GMA-12 DFCs

Summary of Environmental Stewardship's Comments and Requests

Presented to
GMA-12
January 15, 2021 Virtual Meeting

Figure 1. Predicted reduction of discharge of groundwater into the mainstream Colorado River due to combined pumping (Old GAM).

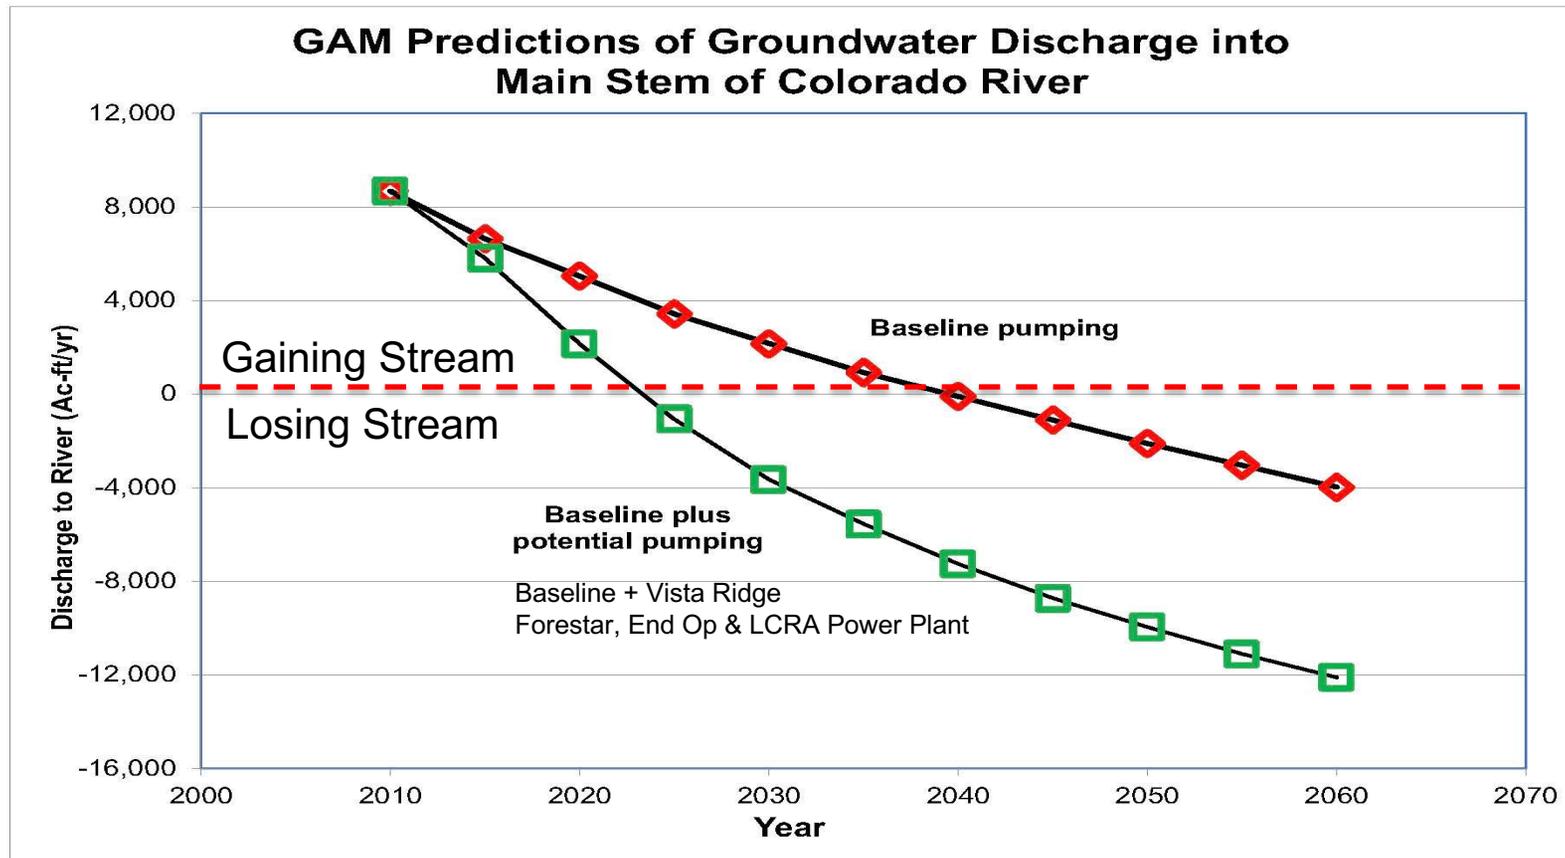
- Adopted 2017 DFCs (Old GAM):

Figure 2. Predicted reduction of discharge of groundwater into the mainstream Colorado River due to DFC Run 3 and Scenario S-7 (New GAM).

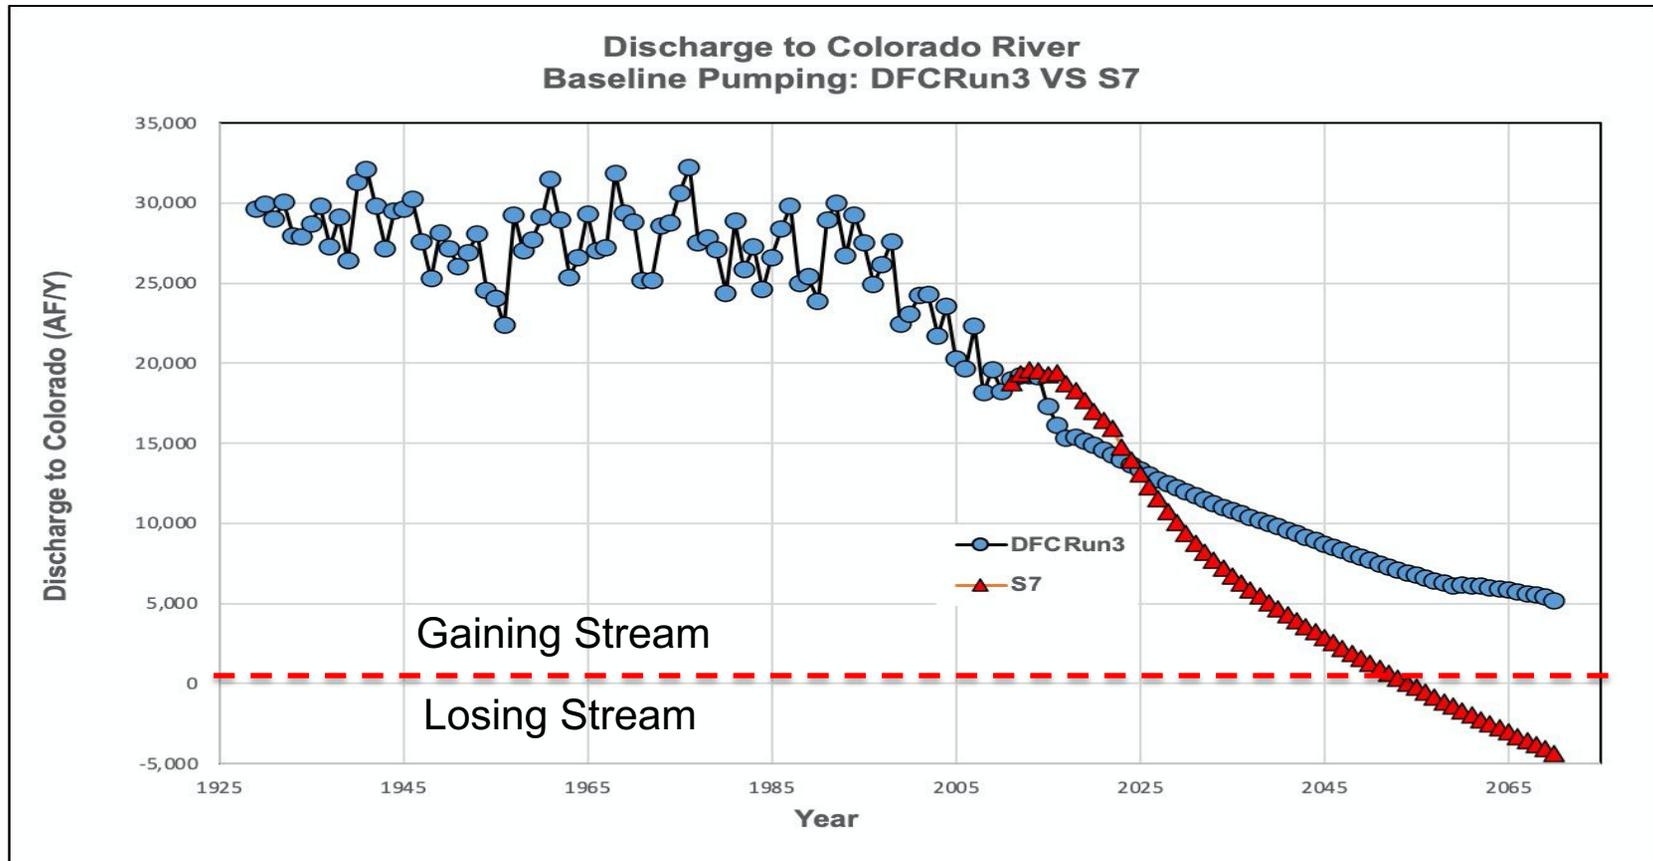
- Average Pumping Amount:
 - **DFCRun3 = 50,900 acre-feet per year average pumping all aquifers**
 - **Scenario S-7 = 116,000 acre-feet per year average pumping all aquifers**
- The New 2018 GAM (DFCRun3- Current Adopted DFCs) predicts:
 - **Pumping *will reduce discharge* to the main stem of the Colorado River by about 14,000 ac-ft per year from 2010 to 2070.**
 - **Pumping *will not reverse its historical relationship* to the aquifers in the current planning period.**
- The New 2018 GAM (S-7)predicts that:
 - **Pumping *will reduce discharge* to the main stem of the Colorado River by about 24,000 ac-ft per year from 2010 to 2070.**
 - **Pumping *will reverse its historical relationship* to the aquifers by about 2050.**

- **By comparison:**
 - **The new GAM predicts that Scenario S-7 will reduce outflows by about 10,000 ac-ft per year more than DFC Run 3.**
 - **The new GAM predicts that Scenario S-7 will cause a reversal in the surface water-groundwater relationship to occur about 2050 whereas DFC Run 3 does not predict a reversal within the planning period.**
 - **Scenario S-7 (New GAM) is comparable to Baseline + potential pumping in the Old GAM.**
 - **Both predict the same magnitude of reduced outflow from the aquifer to the Colorado River; about 22,000 to 24,000 acre-feet per year.**

Figure 3: Groundwater Discharge to four tributaries of the Colorado River located primarily in Bastrop County, TX (New GAM).

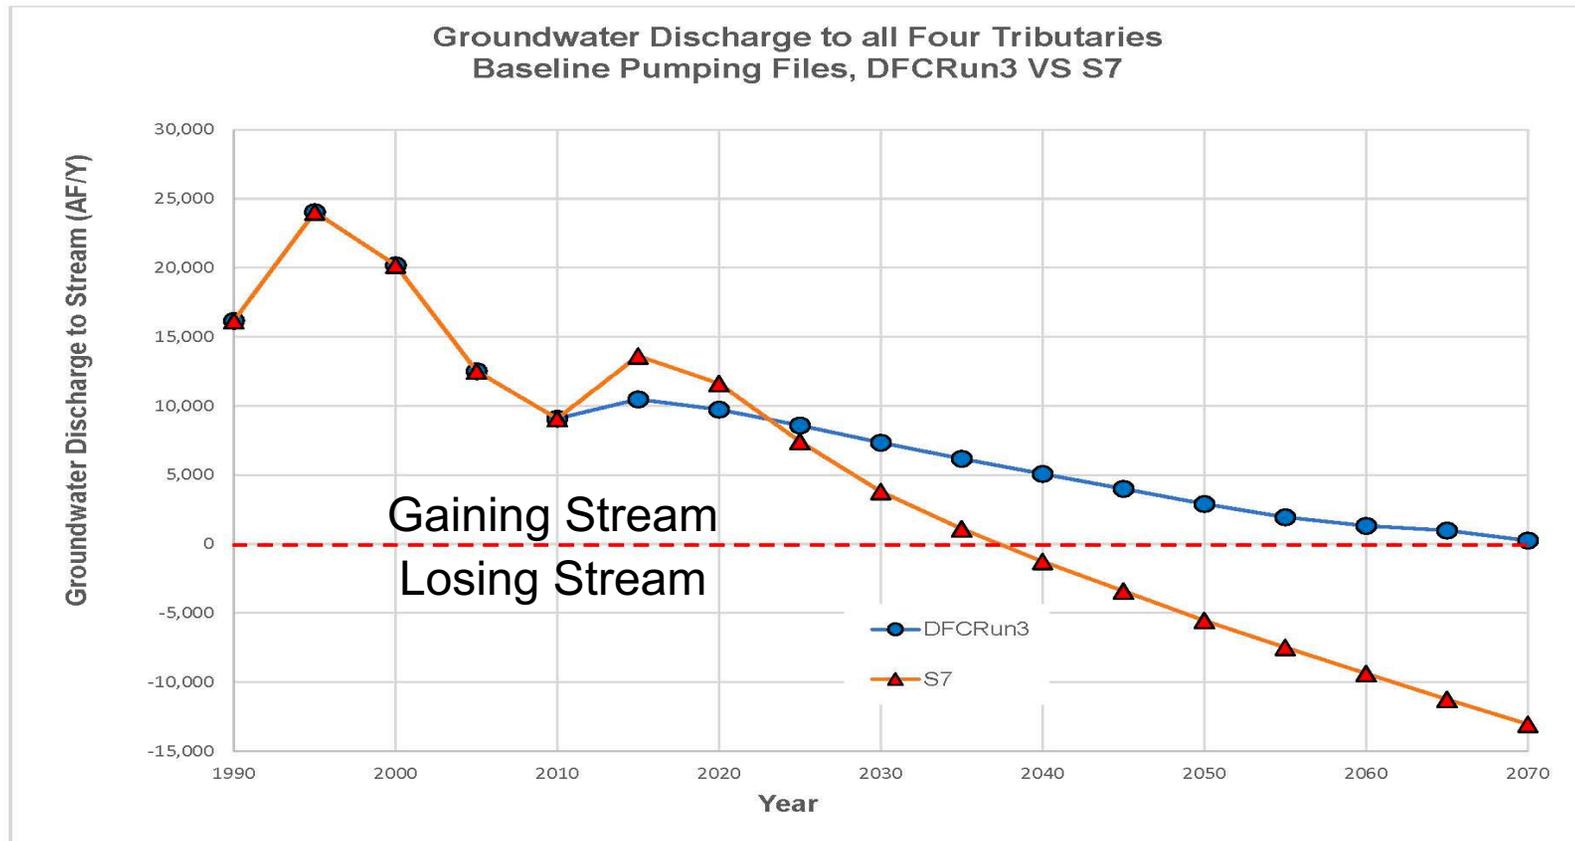
- **Combined discharge to the four tributaries:**
 - **Historic outflows were significantly higher than during development**
 - **Outflows declined during the early development period**
 - **Outflows are predicted to continue to decline as pumping increases in the current development period**
 - **Gain/Loss relationship will reverse during the planning period for currently adopted DFCs**
 - **S-7 pumping will accelerate the reversal by about three decades**

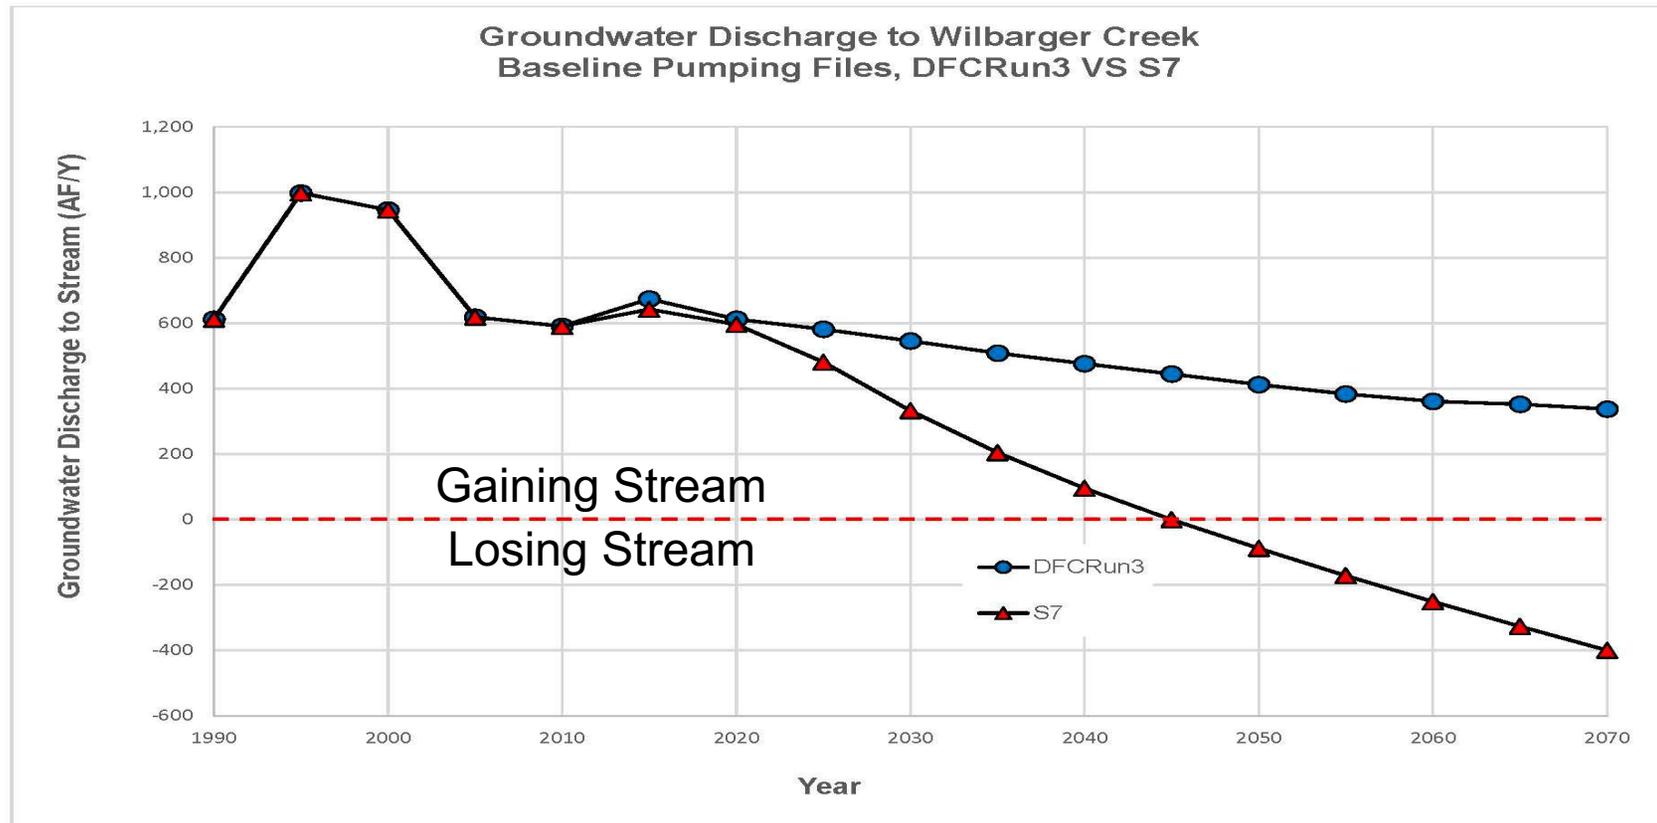
New GAM Predictions for Wilbarger Creek

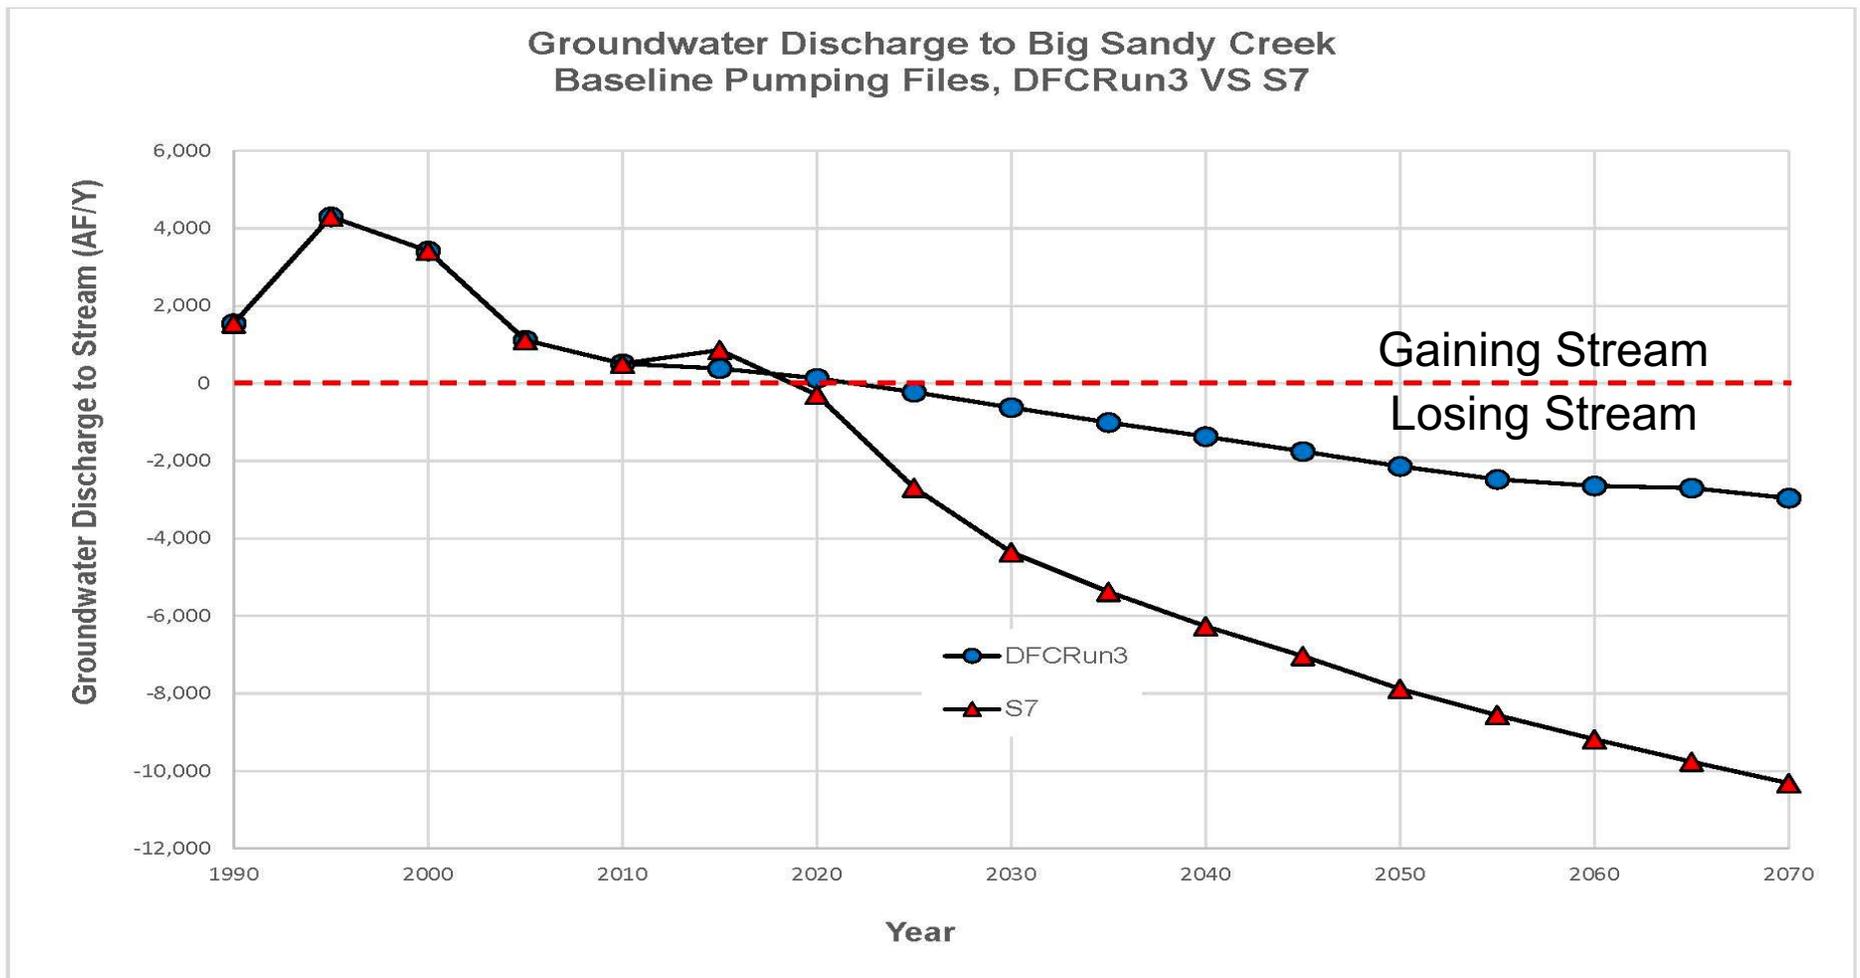
New GAM Predictions for Big Sandy Creek:

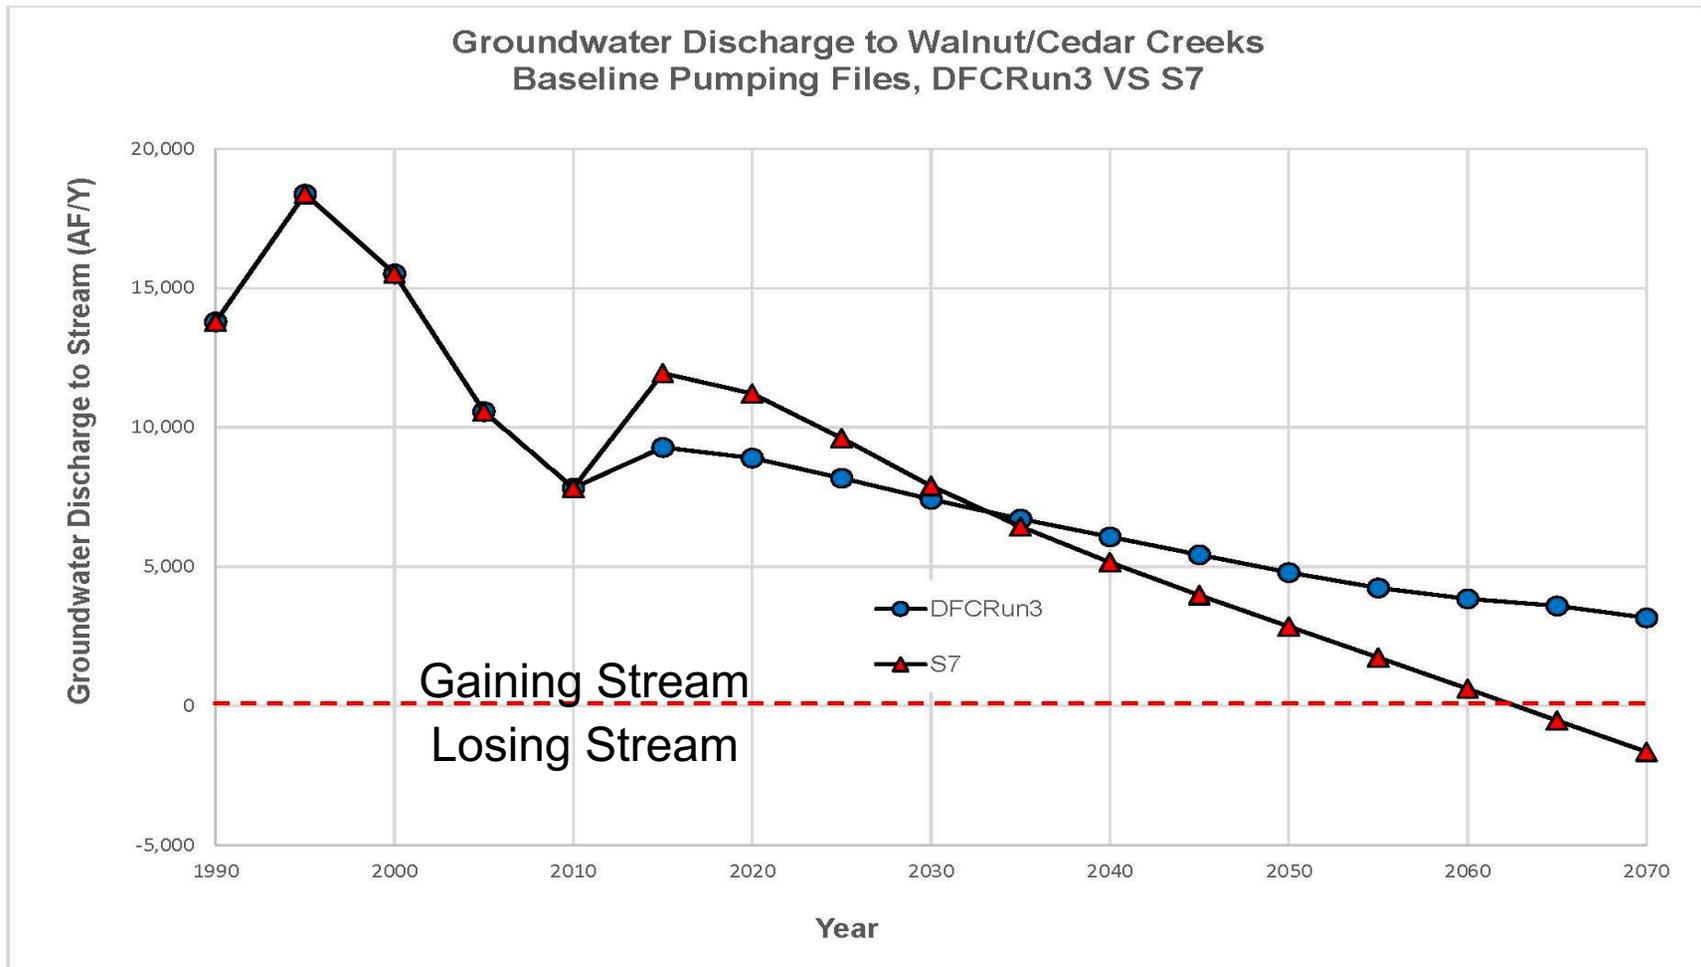
New GAM Predictions for Walnut/Cedar Creek:

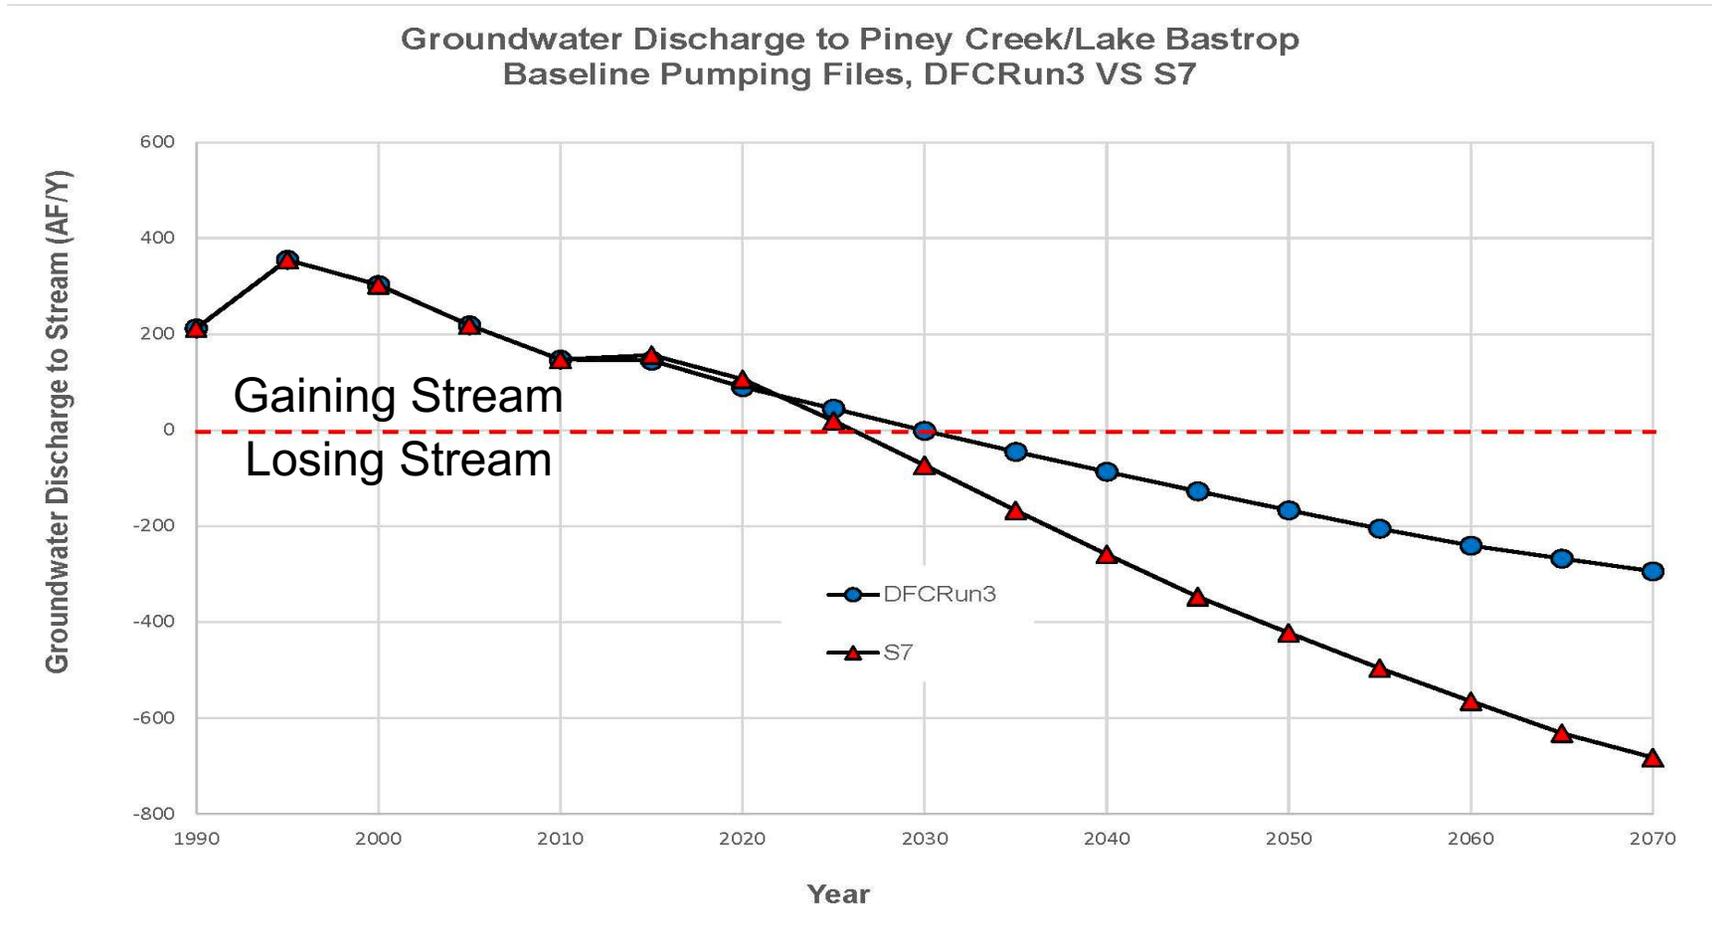
New GAM Predictions for Piney Creek/Lake Bastrop
